CITY OF LA CAÑADA FLINTRIDGE

MEMORANDUM

Subject: Second-Floor Review 14-17
Koeppen Residence
4812 Crown Avenue

Front (West) Elevation: redesigned submittal (above); original submittal (below)

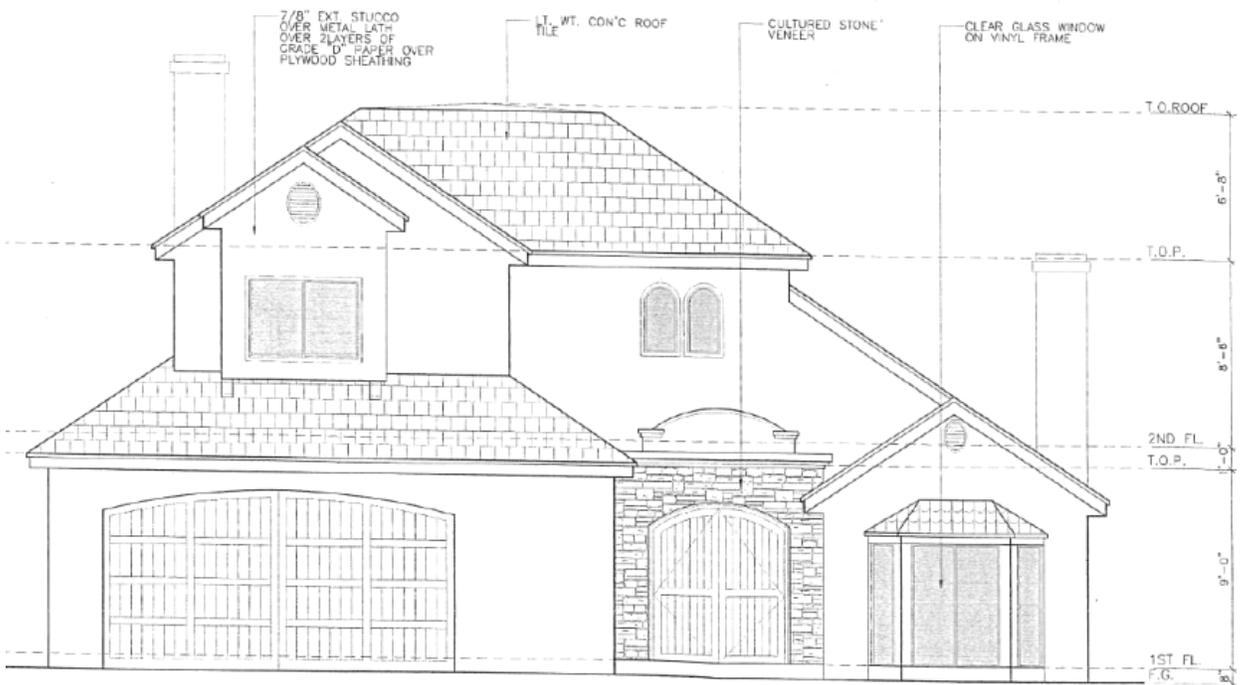
The resubmitted design is seen on the following page, along with the original submittal. The redesigned project responds to Condition 16 as follows:

- a. The front porch now extends forward eight feet. It meets the code criteria for exempt roofed area.
- b. The reveal at the roof has been provided.
- c. The entry is marked by a simplified portal that is harmonious with the house design and neighborhood setting.
